BULLETIN N. 1 OF 06/12/2021

SUBJECT: NEW EASYKART 2022:

- EASYKART 60 – EASYKART 60 ACADEMY NEWS
- EASYKART 100/125 NEWS

• New front and side pods

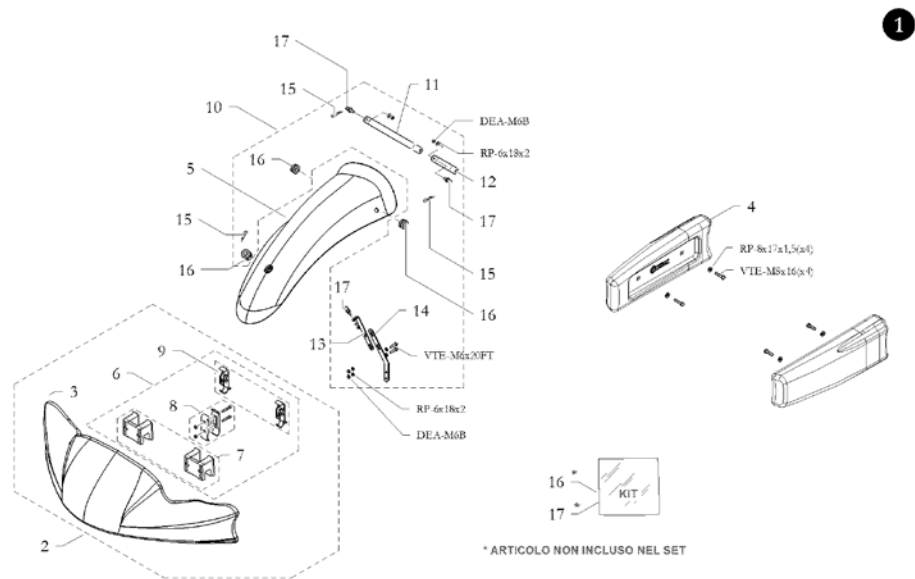
The new Easykart 60 and 60 Academy will be equipped with the KG MK20 front pod and front panel, and FREELINE MINI EVO side pods. The supports of the side pods and the brackets for fixing the new front panel are also changed.

2. EASYKART 100/125 NEWS

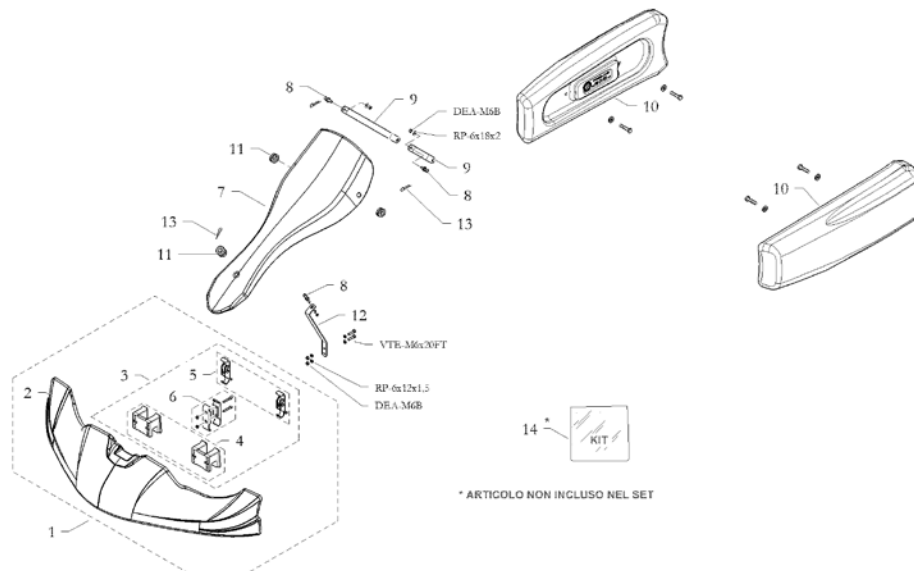
The new Easykart 100 and 125 will be equipped with the KG 507 front pod.
